NO.	DATE	REVISION
2	4/4/17	ADDENDUM 2

ALTERATION / ADDITION
OUTAGAMIE COUNTY ADMINISTRATION CENTER
S. WALNUT & W. 8TH, APPLETON, WI 54911
LEVEL 780.00 - COMPOSITE EXISTING FIRE PROTECTION PLAN

DESIGNED NDK	DRAWN NDK
PROJECT NO. 00002-61600160	
DATE MARCH 3, 2017	
SHEET NO. FP200

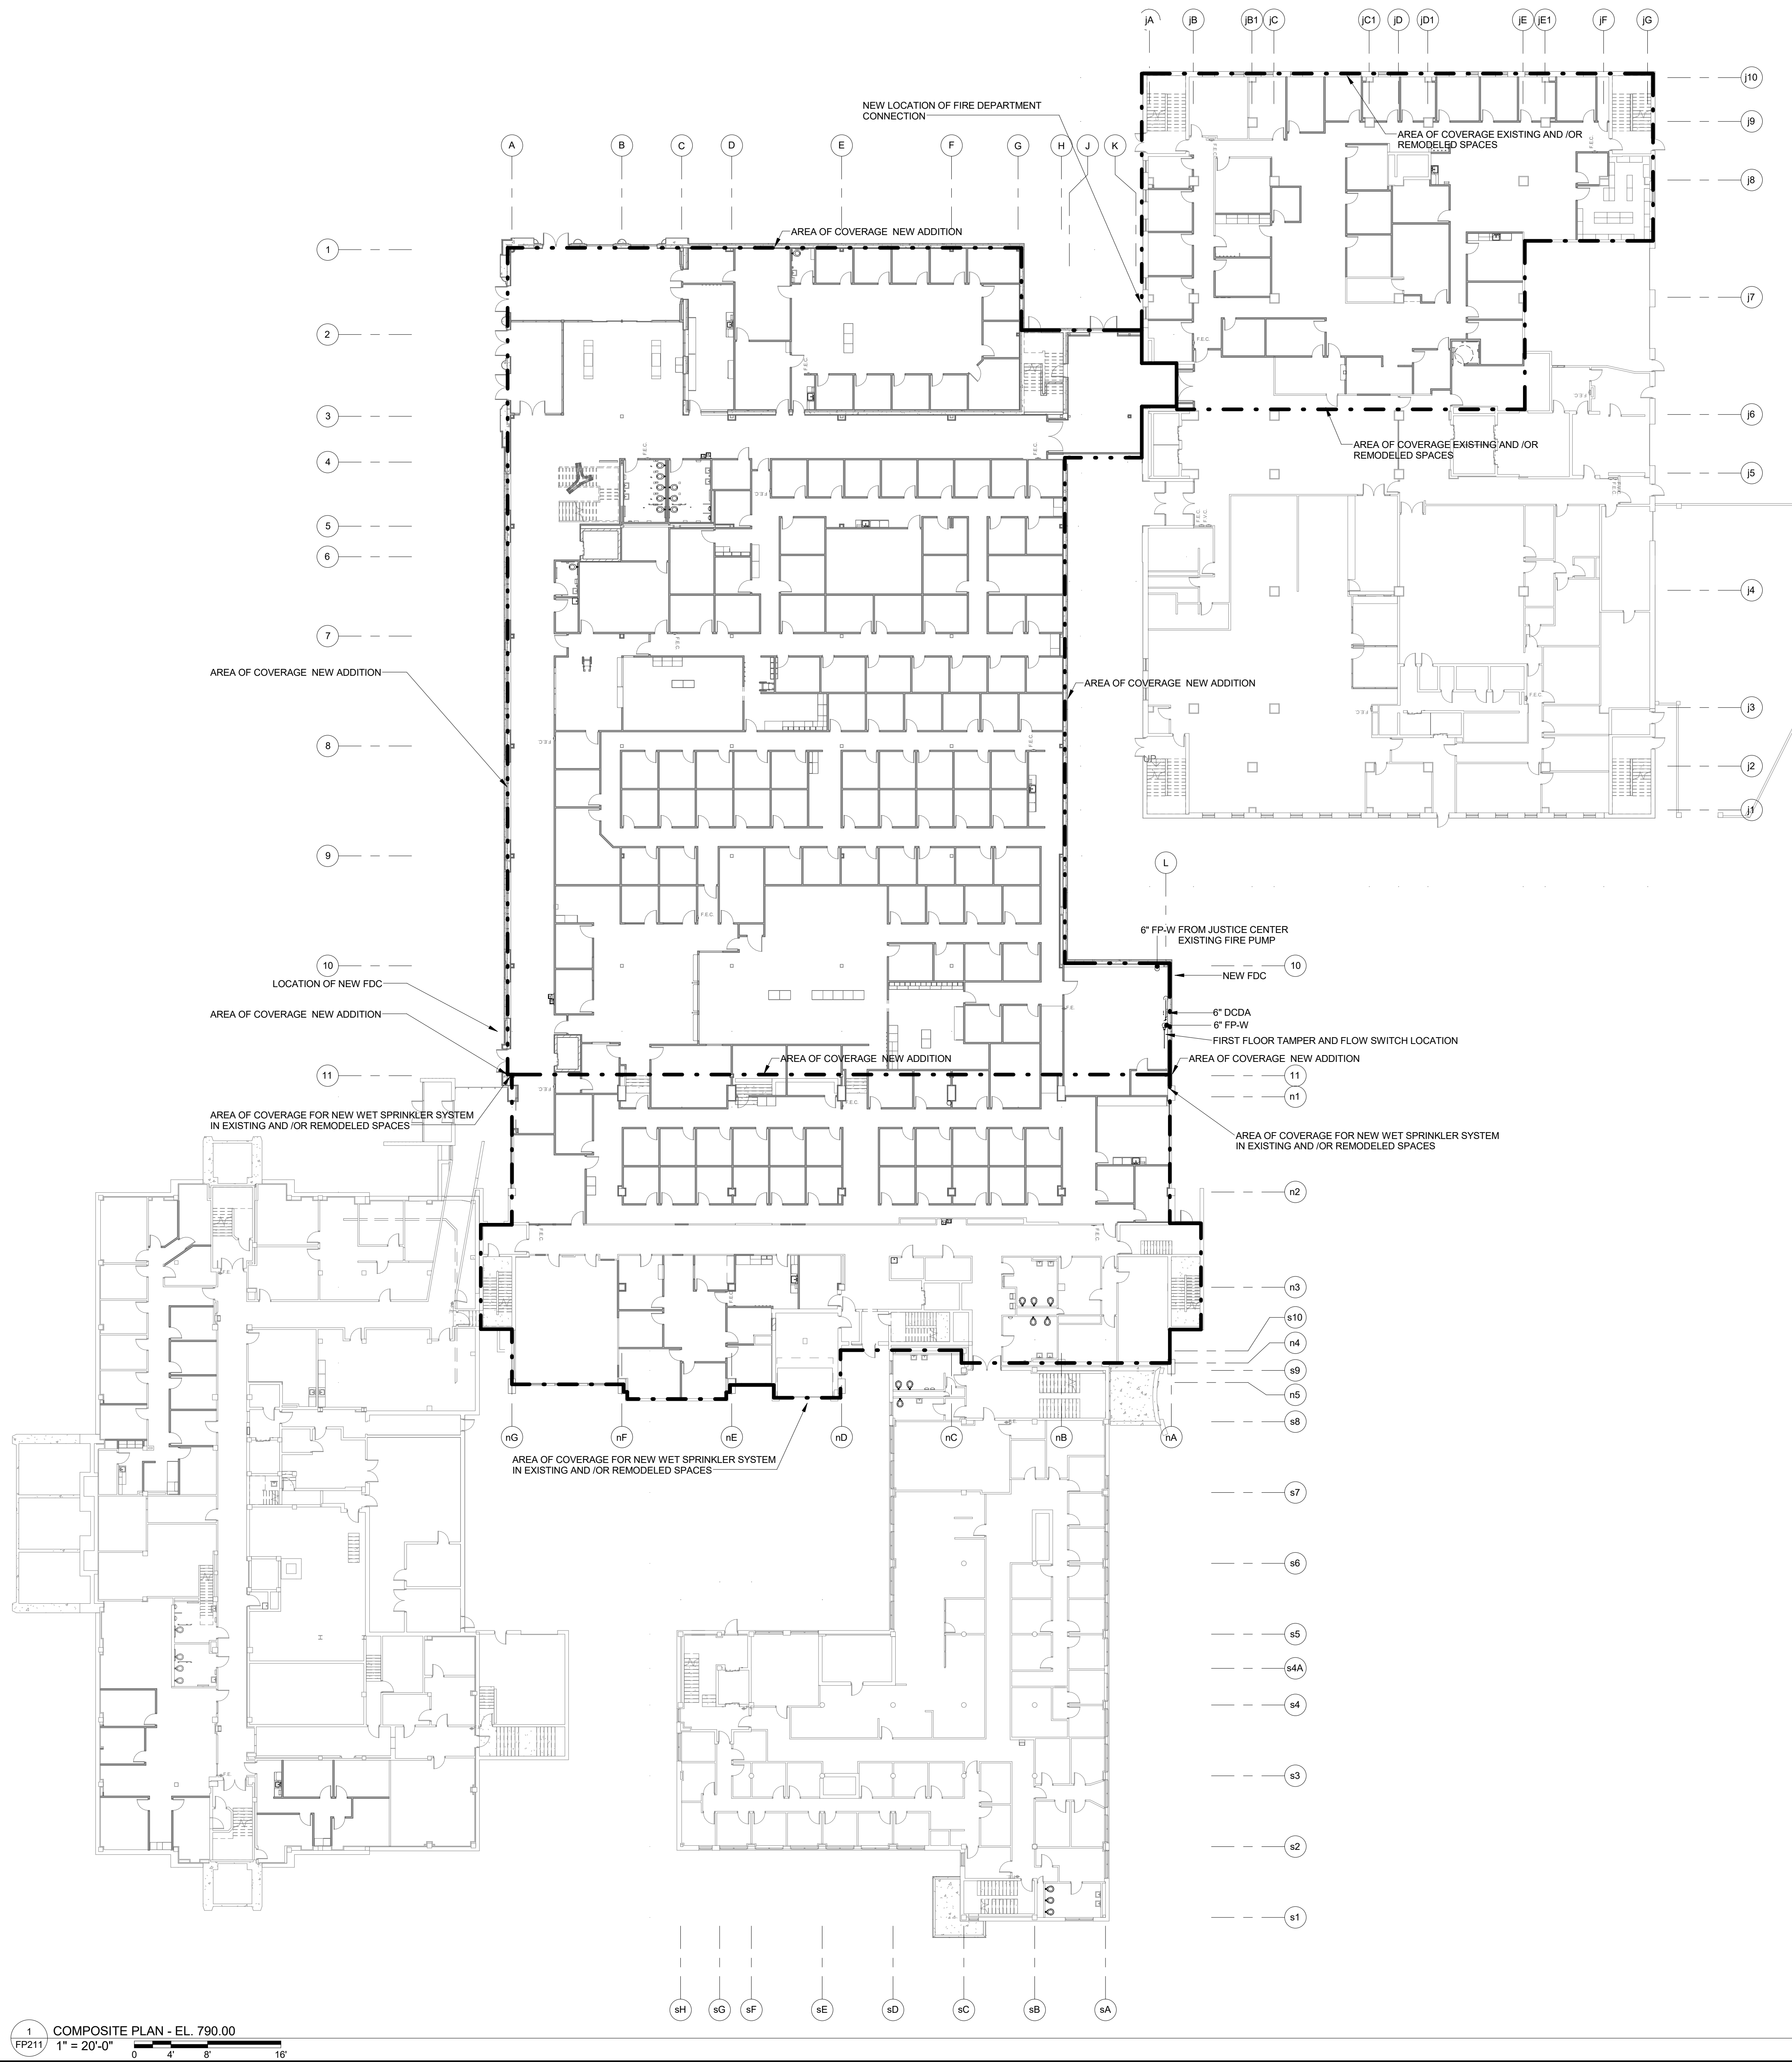
NOTE: IT ROOMS IN THE ADDITION SHALL BE FIRE RATED AND NOT SPRINKLED.

1
FP212
COMPOSITE PLAN - EL. 805.00
1" = 20'-0"

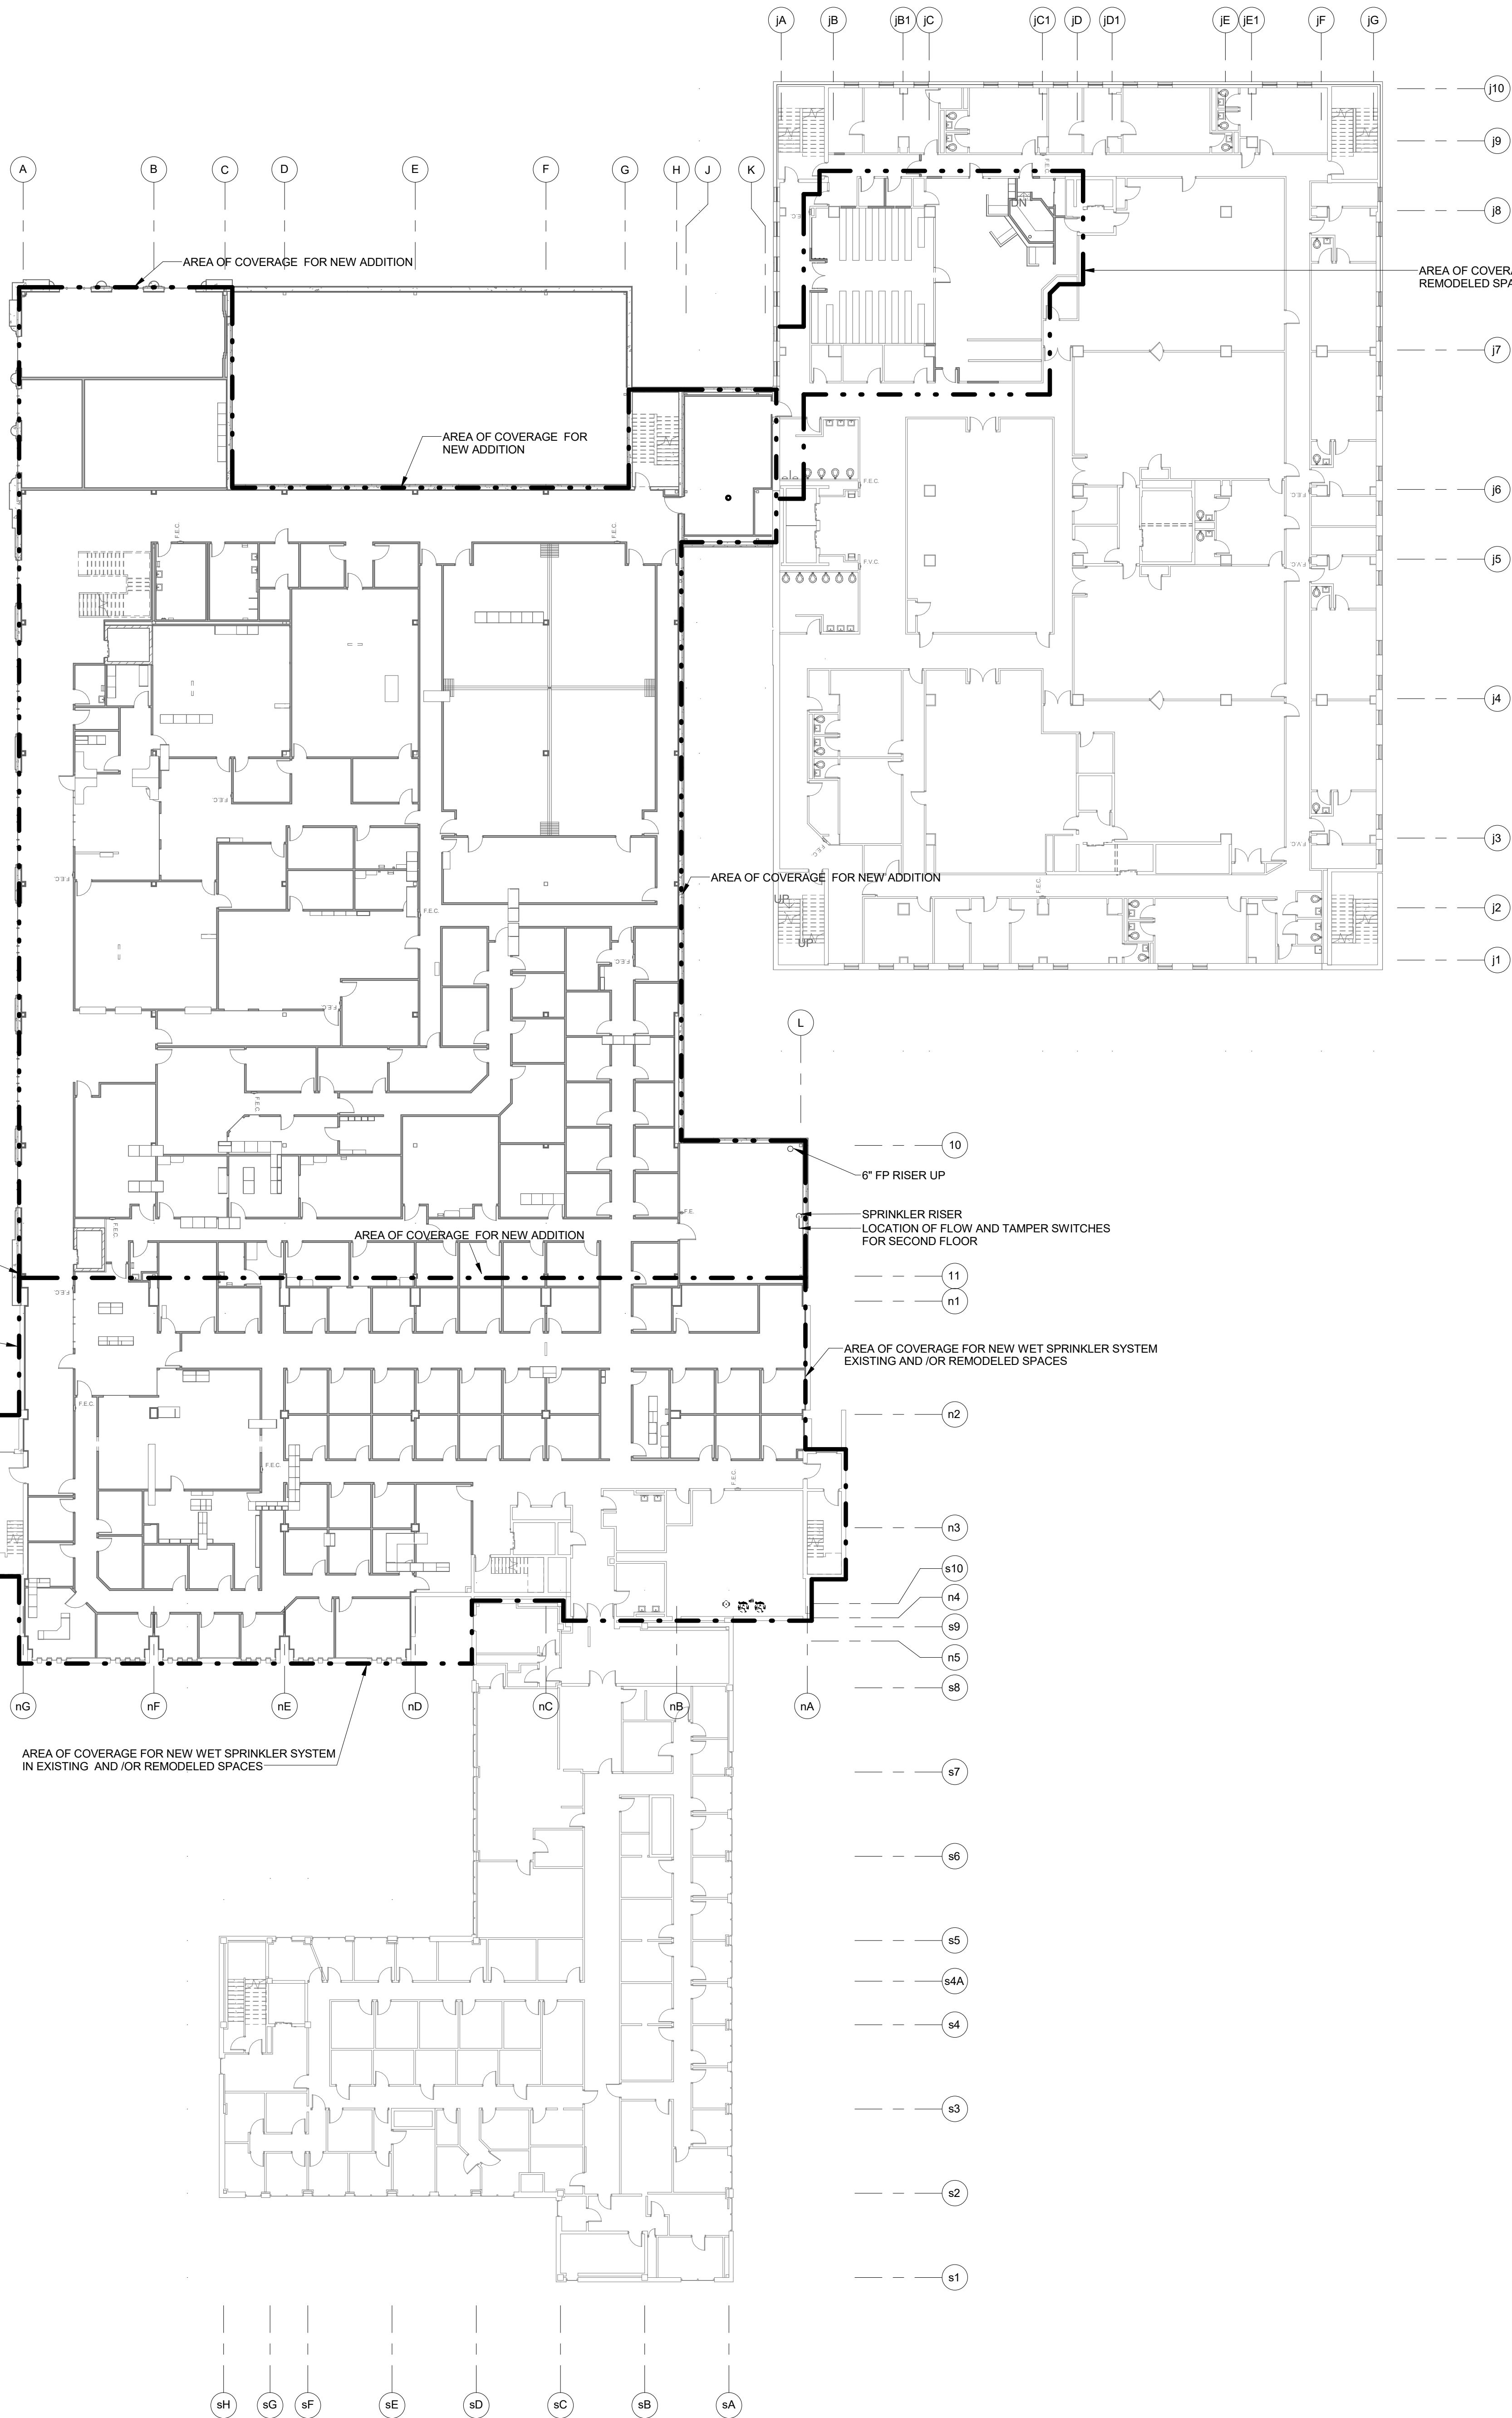
NOTE: IT ROOMS IN THE ADDITION SHALL BE FIRE RATED AND NOT SPRINKLED.

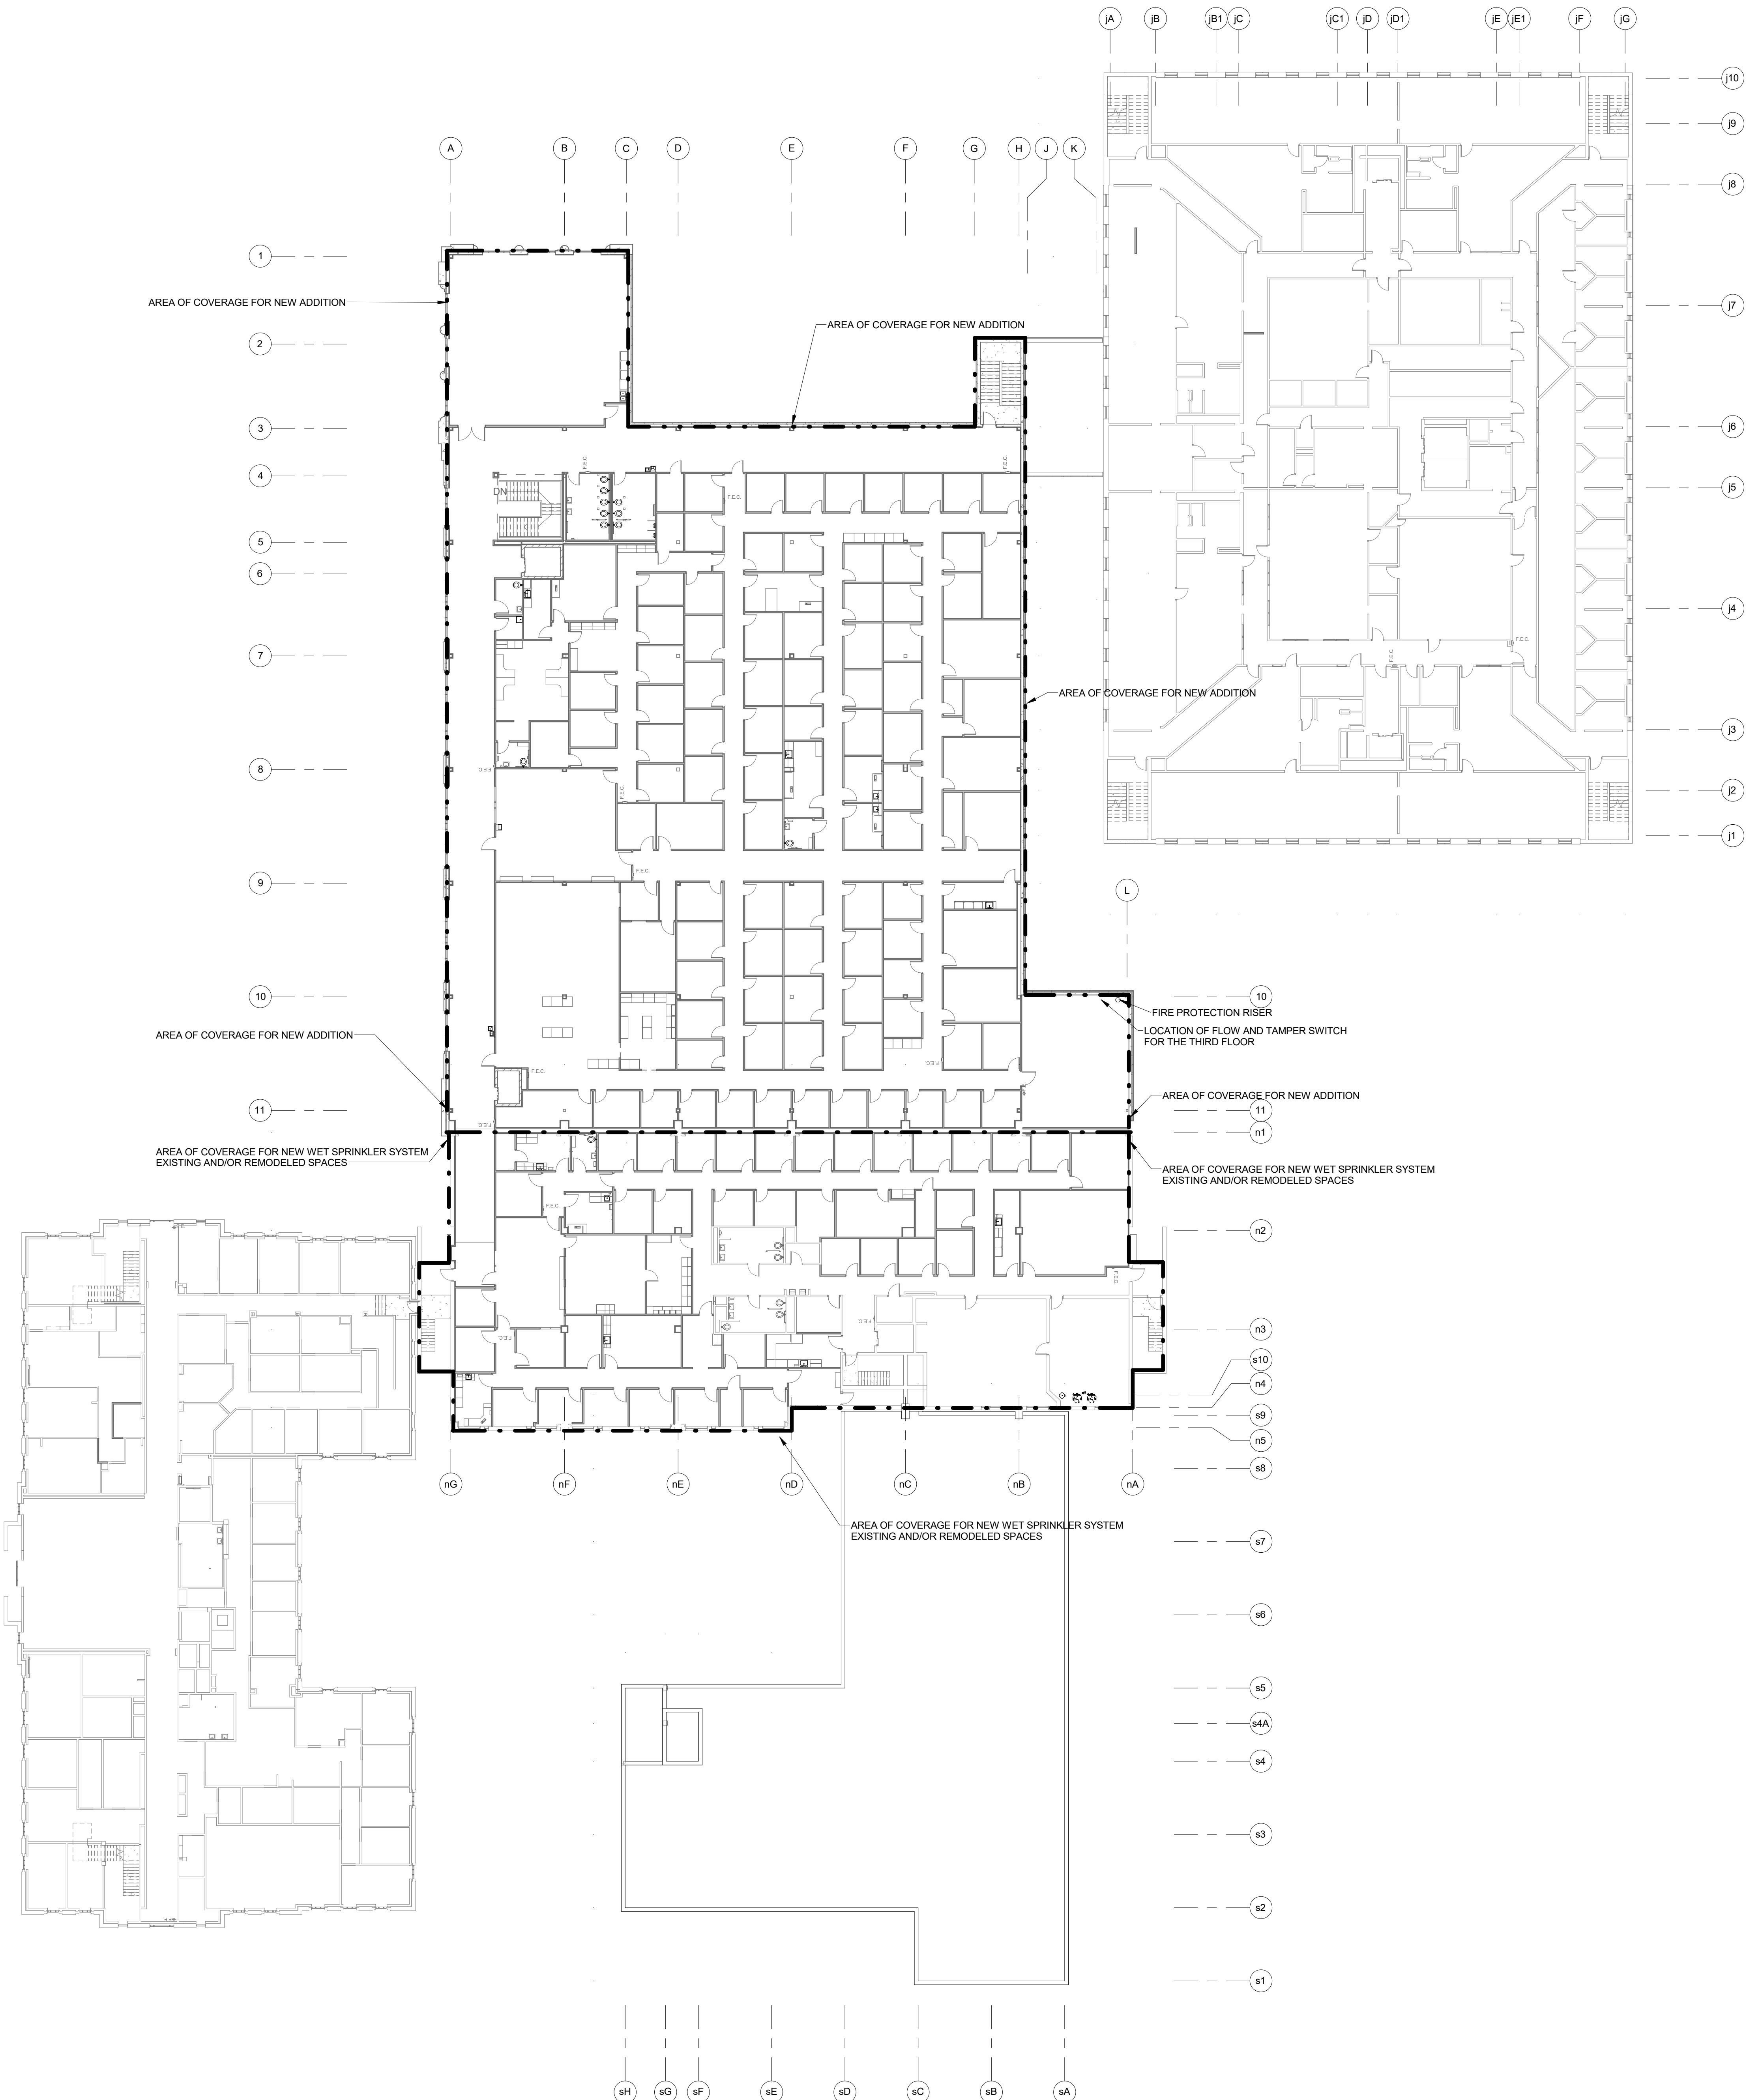
NOTE: IT ROOMS IN THE ADDITION SHALL BE FIRE RATED AND NOT SPRINKLED.
